Product Change Notice (PCN)

PCN Number: **PCN-0450984R-01**

Product(s) Affected: SJ1-3533N, SJ1-3534N, SJ1-3535N

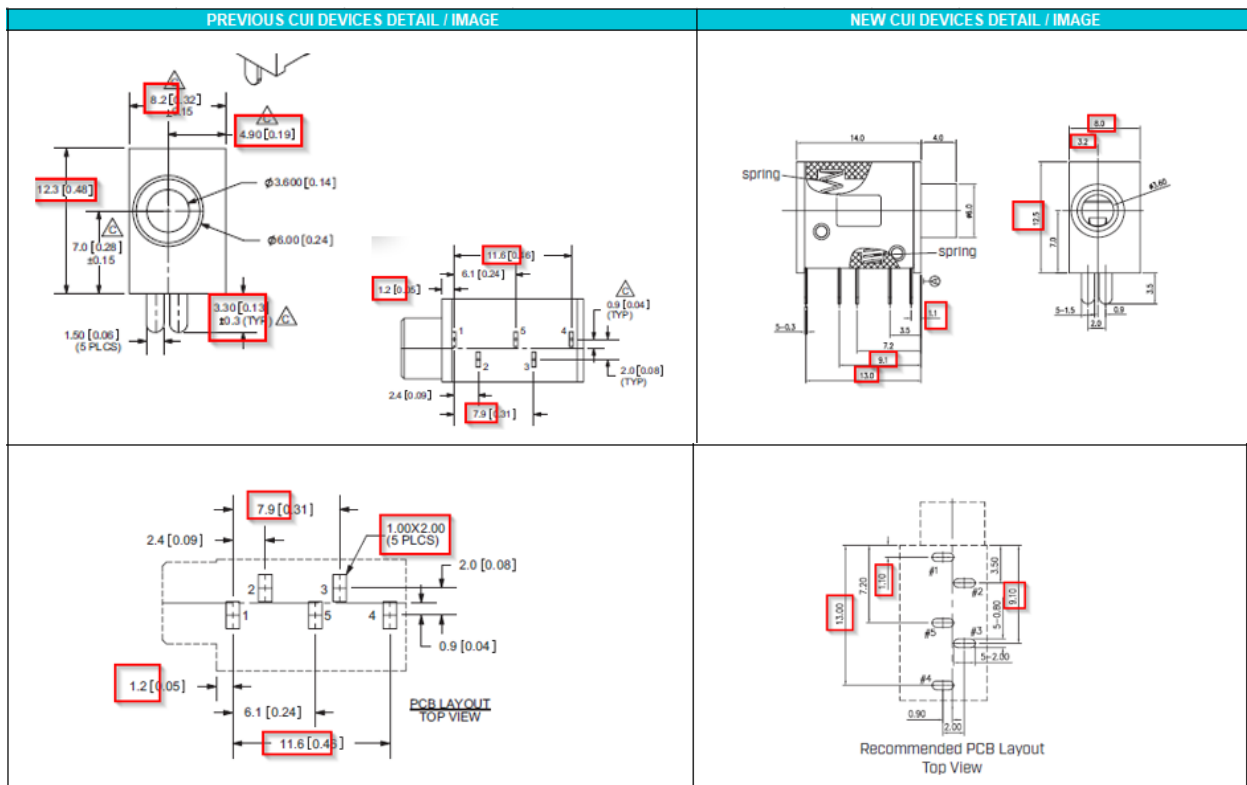
Description of Change: mechanical and material differences as shown below:

MATERIAL	PLATING
terminal 1	brass	tin
terminal 2	brass	tin
terminal 3	brass	tin
terminal 4	brass	tin
terminal 5	brass	tin
bushing	brass	nickel
spring	stainless steel	
plastic	PBT

DESCRIPTION	MATERIAL	PLATING/COLOR
terminal 1	brass t=0.30	silver
terminal 2	brass t=0.30	silver
terminal 3	brass t=0.30	silver
terminal 4	brass t=0.30	silver
terminal 5	brass t=0.30	silver
springs	stainless steel	
bushing	copper alloy (H59)	nickel
housing	PBT (UL94V-0)	black
cover	PBT (UL94V-0)	black
